Access Compliance Report Public Rights-of-Way (Curb Ramps)

Main Street: YORKSHIRE_AVE		Cross Street: MOSSLER_ST		Location:	NW
ADA ID: RPAT211129125257	Ramp Type: Type 4 - Parallel	Initial Pass/Fail: Fail	Overall Compliance: No	Severity Score:	2
Codes/Mitigation Info/Possible Solution			Field Measurements/Component Compliance

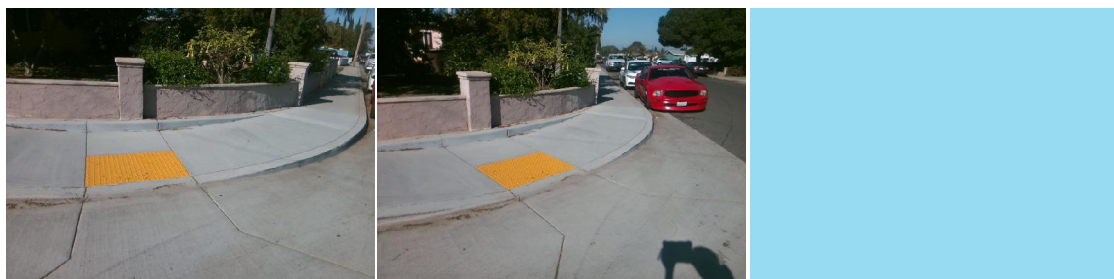
Compliance	Description	Data	Compliance	Description	Data
N/A	Ramp Length LT (in)	136	N/A	Ramp Length RT (in)	135
Yes	Ramp Width LT (in)	65	Yes	Ramp Width RT (in)	63
Yes	Ramp Run Slope LT (%)	6.1	Yes	Ramp Run Slope RT (%)	7.1
Yes	Ramp Cross Slope LT (%)	1.4	No	Ramp Cross Slope RT (%)	3
N/A	Landing Present	N/A	N/A	DWS Provided	N/A
N/A	Landing Length (in)	N/A	N/A	DWS Contrast	N/A
N/A	Landing Width (in)	N/A	N/A	DWS Length (in)	N/A
N/A	Landing Run Slope (%)	N/A	N/A	DWS Full Width	N/A
N/A	Landing Cross Slope (%)	N/A		DWS Offset Type	N/A
N/A	Landing Movement Obstructed?	N/A	N/A	DWS Offset Left (in)	N/A
	Landing Movement Type	N/A	N/A	DWS Offset Right (in)	N/A
N/A	Landing Shared	N/A			
N/A	Clear Space	Yes			
N/A	Clear Space To Crosswalk (in)	N/A			
N/A	Marked Crosswalk 1	No	N/A	Marked Crosswalk 2	No
	Crossing 1 Direction	S		Crossing 2 Direction	E
	Marked Crosswalk 1 Width (in)	N/A		Marked Crosswalk 2 Width (in)	N/A

Remove & Replace Curb Ramp With Two New Directional Ramps or Equivalent.
